BV1 (M-Note) SYSTEM BLOCK DIAGRAM

BV1 / M-Note Schematic EC Tracking Record A (for DV --> SIV) Dec. 28, 2004**EC #/Page/Description/Part Affected/CMVC #**

PROJECT : BV1	
		Quanta Computer Inc.	
Size	Document Number	EC Record	Rev
Custom			3C
Date:	Thursday, October 06, 2005	Sheet	69 of 73

Size	Document Number	Rev
Custom	USB Ports	3C
Date:	Thursday, October 06, 2005	Sheet 22 of 73

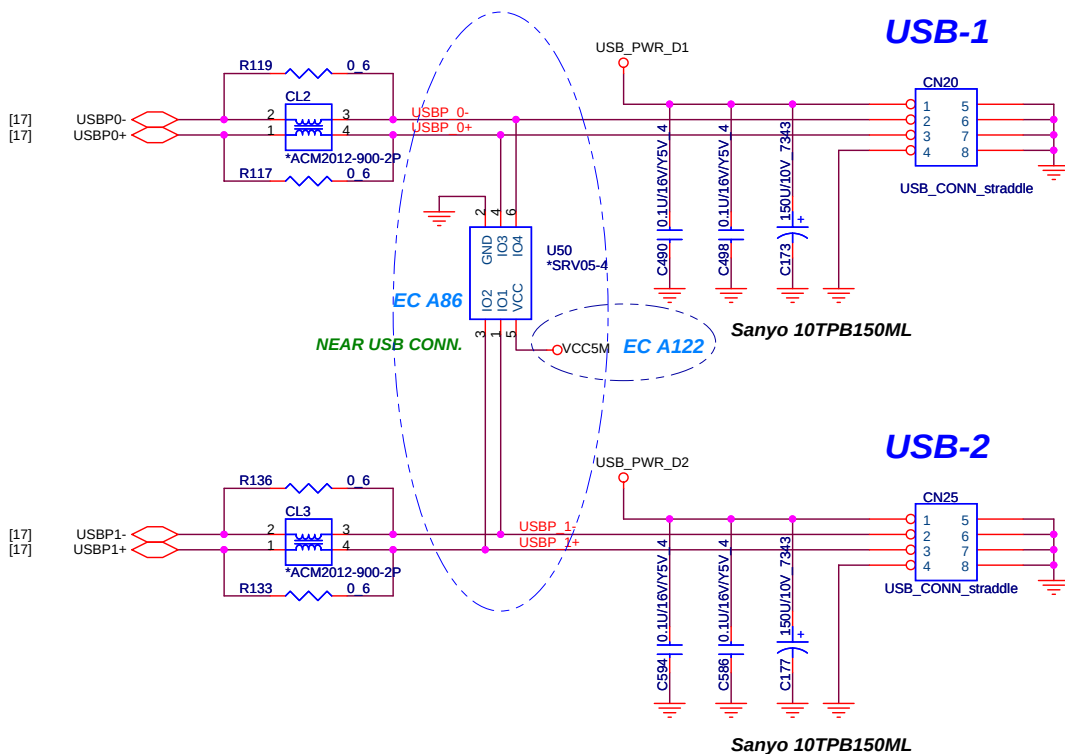
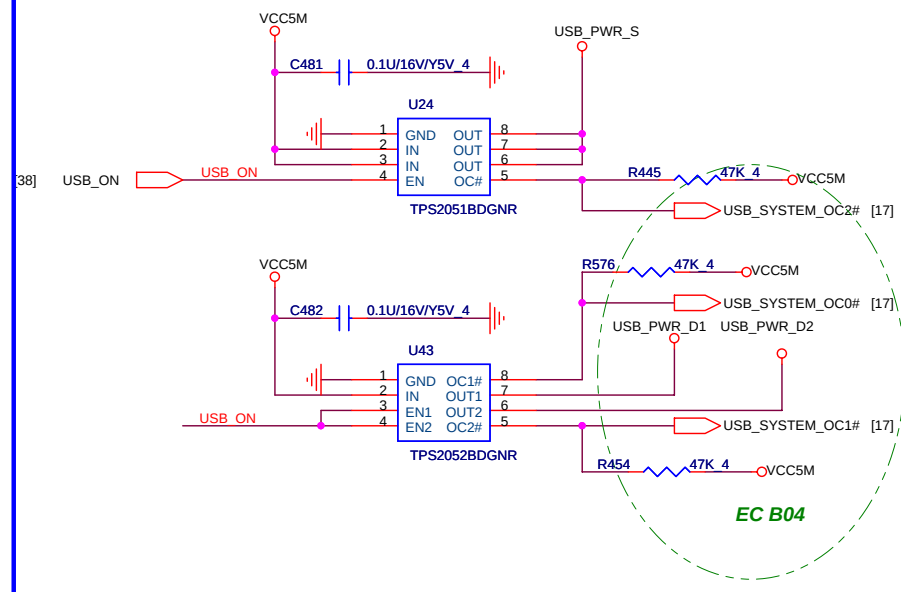
Change to TI solution (TPS2051 + TPS2052 power switch)
2004/12/09 Thunder
